I read this article with pleasure. Regarding its content, 10 observations caught my attention.

(*1) "The origin of Alhama de Aragón and Jaraba thermal springs. Numerical modeling of the regional flow of the geothermal systems, Almazan Basin, Iberian range, Spain"

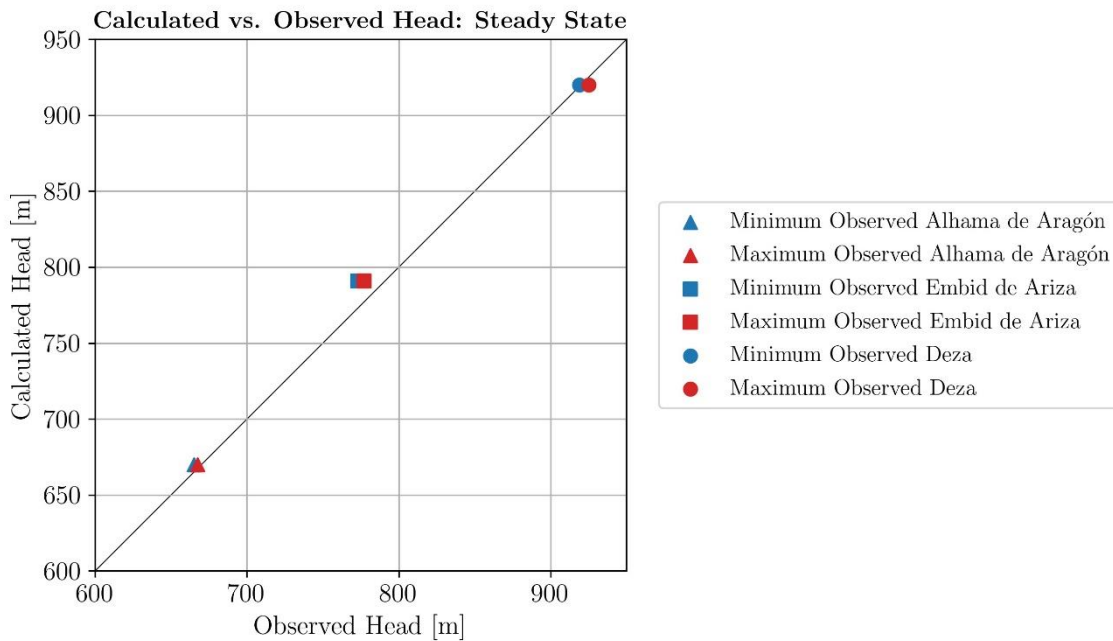
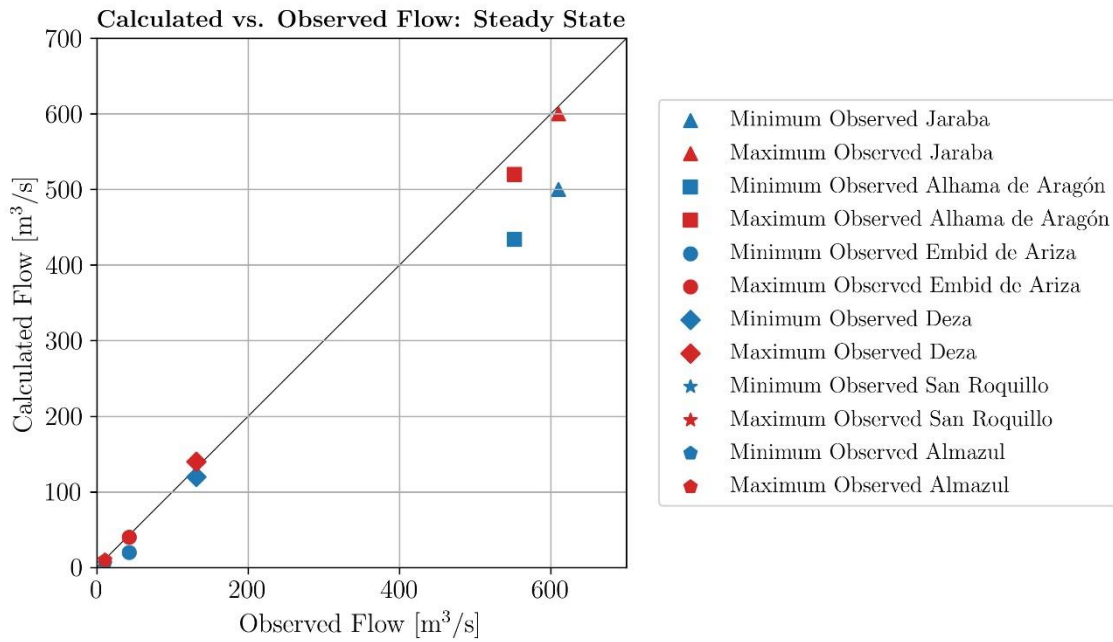
26.- Figures 17 and 18. It is advisable to put different symbols for each spring and include them in the legend. The figures are confusing.

With the intention of improving the quality of the figures, we have improved them significantly, including all the advice you have provided us. It is appreciated. You can check it in the final manuscript where your comment has already been taken into account.

I show you below how the updated figures have turned out.
